Name: Pepper Tree - Filing 4 - F & 29 Roads

REVIEW COMMENTS

TITLE HEADING: Preliminary Plan - Pepper Tree,
Filing #4

RE: Central Grand Valley Sanitation District Review Comments
on Preliminary Sewer Layout for the Pepper Tree Filing #4
Subdivision

PEPPER TREE FILING NO. 4 PRELIMINARY UTILITY PLAN
	ROLLAND ENGINEERING 405 RIDGES BLVD. GRAND JUNCTION, CO. 81502 (303) 242-8188

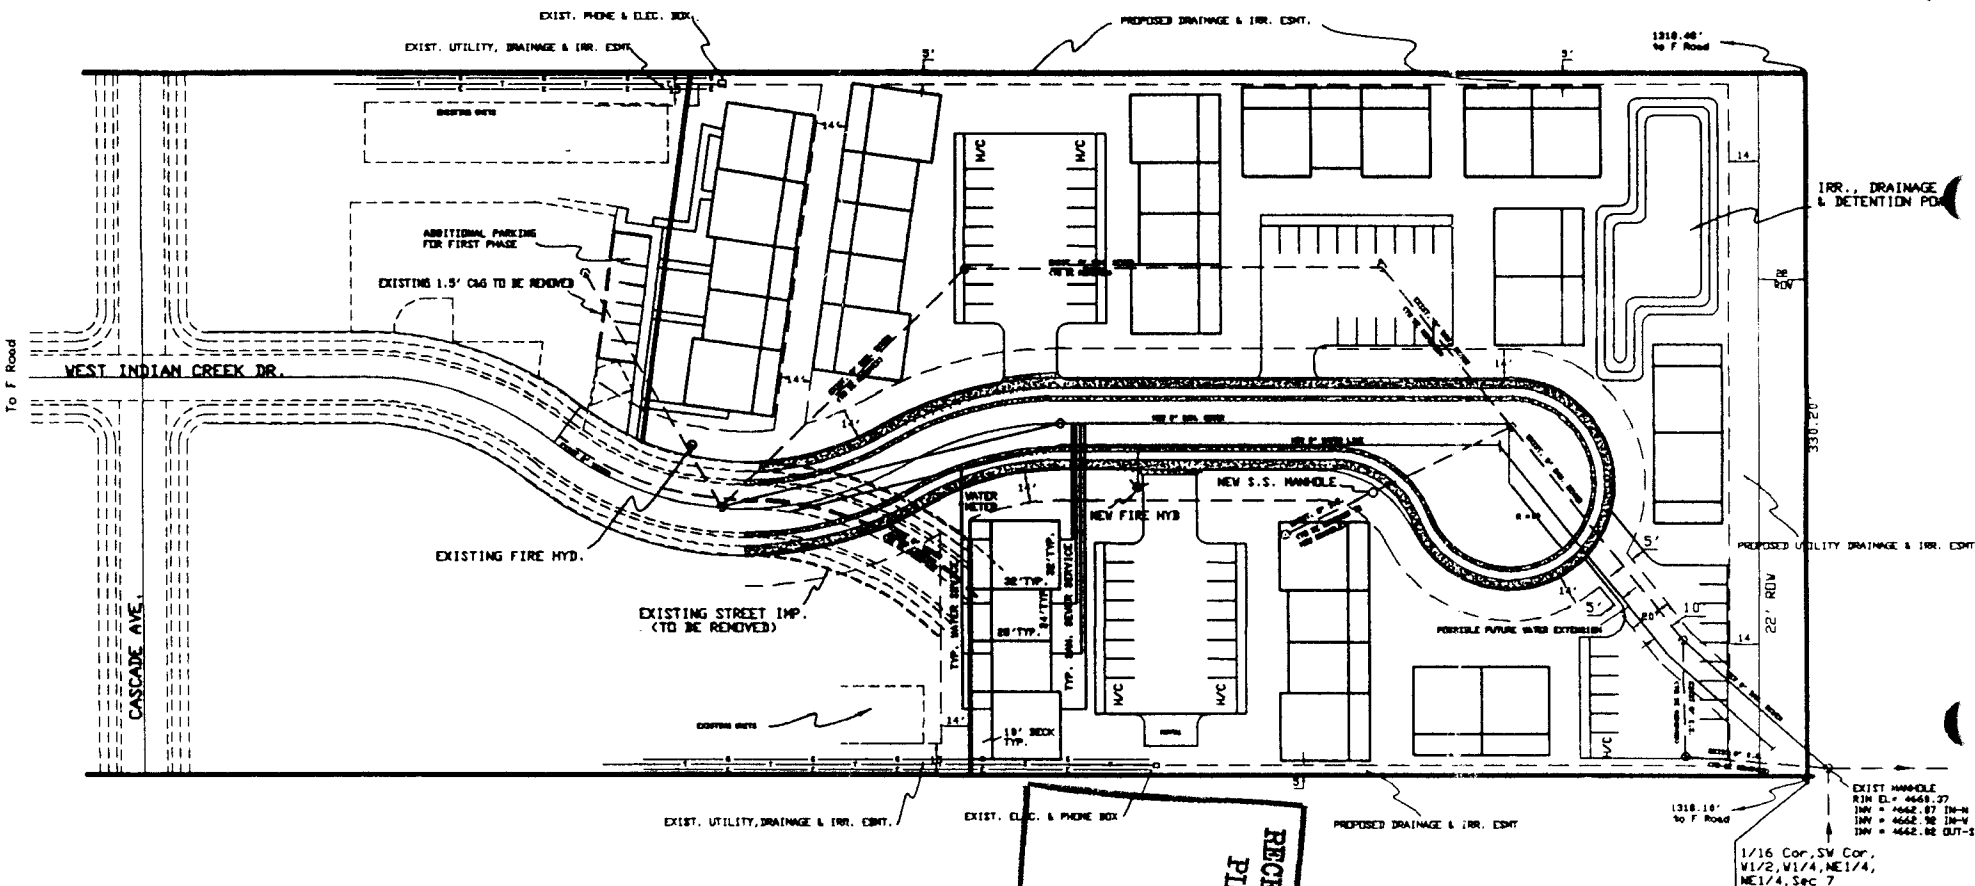
Incomplete information on "Utility Plan". Nothing is stated on the drawing referencing the removal of existing utilities, vacating existing easements or providing new easements for the new alignment. All of these items will have to be addressed on the Final submittal if the Preliminary Plan is approved.

1. Existing sewer lines should be designated with a dashed line and existing manholes with an open circle. New sewer lines should be designated with a solid line, and new manholes designated by solid circles. We ask that these drafting standards be met to clearly differentiate between existing sewers and proposed new sewerline extensions.

2. The proposed new sewer lines, in combination with the existing sewer lines, appear to provide a looped sewer system. We assume some of the existing sewer lines are to be abandoned, since they would be located under the new building structures. If so, the sewer lines to be abandoned should be designated as such, with a clear designation showing disconnection from the proposed sewer system.

3. Proposed sewer service lines to the individual town-homes should be shown on the preliminary layout.
4. The existing sewer lines at the discharge point to the District's system should be shown to indicate the location of the outfall from the subdivision.

6. The proposed new sewer line in the southwest corner of the property is shown to be approximately 3 feet from the proposed building footprint. The District will require a minimum 10 foot separation between the new sewer line and any building structure.
7. Upon acceptance of the preliminary sewer plan, it will be necessary for the petitioner to submit final Plans on the proposed new sewer line extensions, to include the utilities composite, and detailed plan and profile sheets. Easements will be required where the sewer line is not located within the street right-of-way, even though located within the common area of the subdivision.
8. The petitioner will also be required to execute the District's Sewer Line Extension Application and Agreement upon submittal of the final design plans.

We have indicated on the drawing the existing utilities we will be removing. We are uncertain at this time if recorded easements exist for these proposed removals. New easements will be provided for all utilities.

- 1) Drafting standards delineating existing and proposed sewer lines will be met.
- 2) Some of the existing sewer line will be abandoned and will be clearly designated on the plan.
- 3) Typical proposed service to individual townhomes is shown.
- 4) See plan drawing.
- 5) Petitioner will notify the District and pay appropriate tap fees for first phase of development when the final for Phase I is accepted.
- 6) Ten foot separation between new sewer lines and buildings will be maintained.
- 7) Final plans will be submitted upon acceptance of the preliminary sewer plan. Detailed plan and profile sheets along with a utilities composite will be included.
- 8) The petitioner will execute the District's Sewer Line Extension Application upon submittal of the final design plans.

PEPPER TREE FILING NO. 4
PRELIMINARY
SITE PLAN

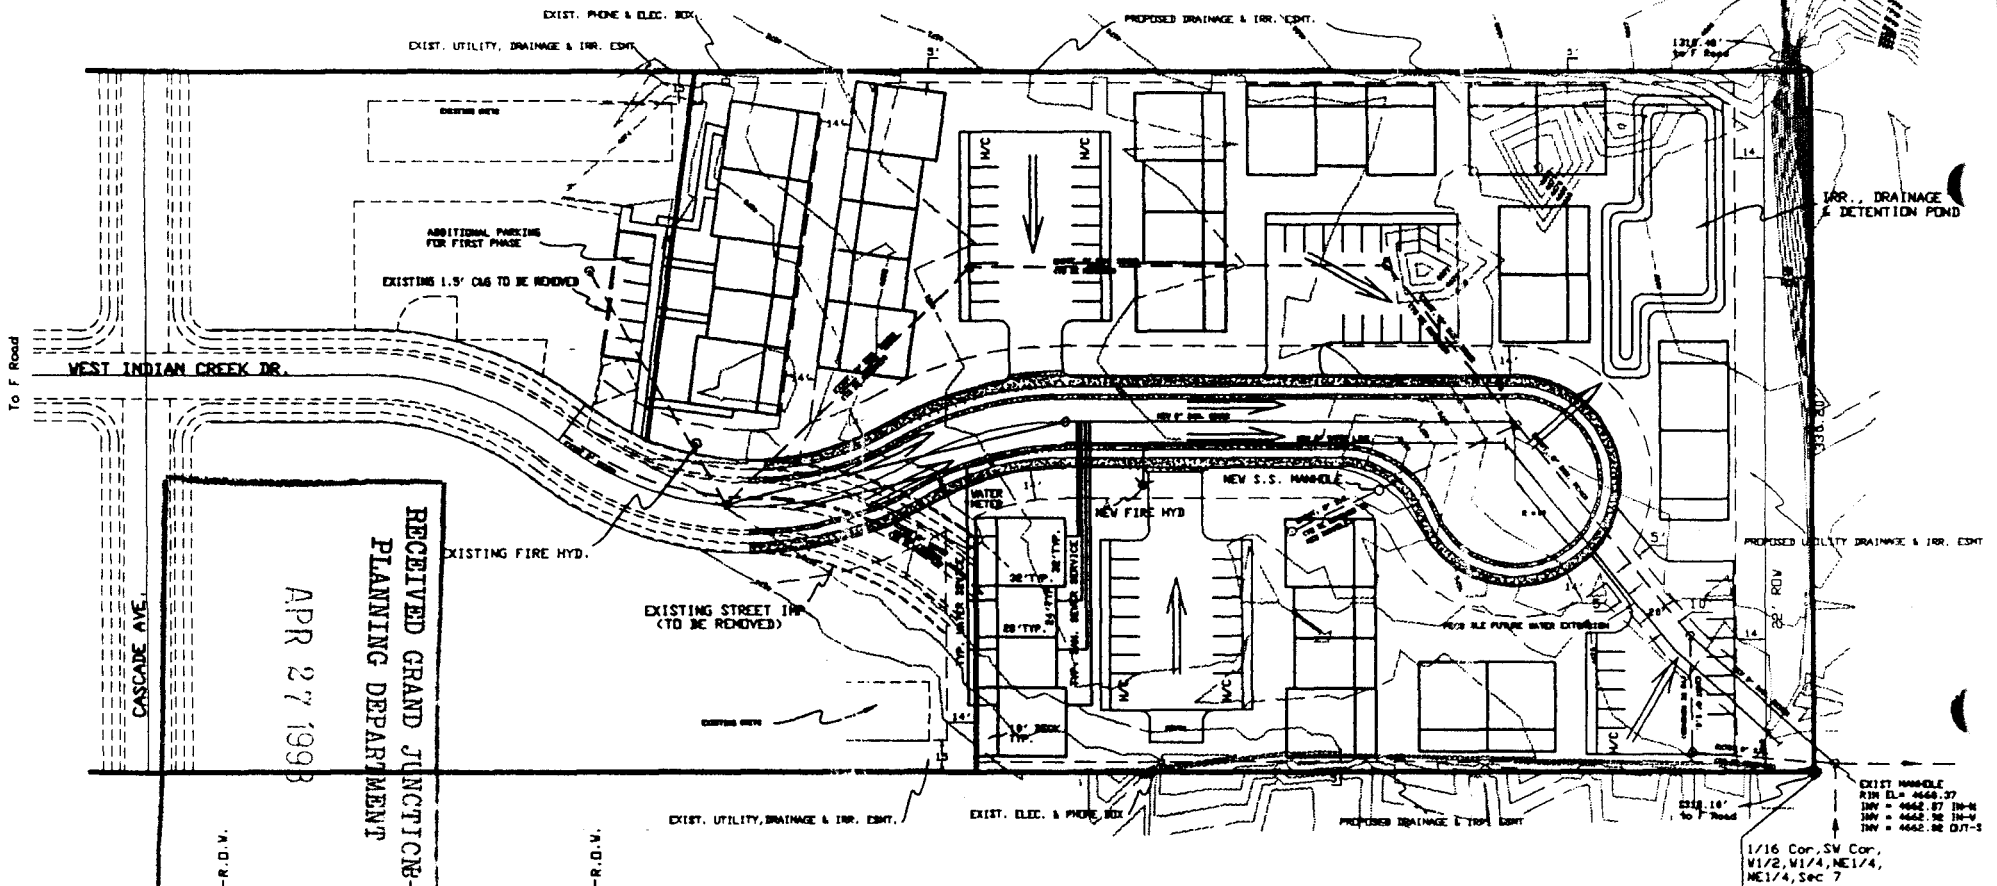
4/19/93 - The Fire Department is unable to approve the plans as submitted since the proposed line length feeding the end hydrant is in excess of 1,000 feet. The Department would consider a decrease in the proposed number of units per building to meet the requirements of the ordinance dealing with line lengths and hydrant spacing.

The Final Plan submittal must also address the following: 1) provide stormwater conveyance swales at the west, east, and south sides of the subdivision; 2) provide scales on drawings; and 3) the triplex appears to be beyond the 150-foot radius fire protection limit.

The revised site plan submitted in response to review comments shows a 5' setback along the east and west property lines. The original proposal was for a 10' setback. The 10' setback should be required.

We have adjusted the fire hydrant location so it does not exceed the 1000 foot limit. We have also adjusted the number of units per building to comply with the fire code (i.e. 2 or less units 250 feet from hydrant; more than two units 150 feet from hydrant). This affects the most southern building only. These buildings will be completed in a later phase of construction and should revisions be made to the 1000 foot limit we will request reconfiguration back to our original concept at that time.
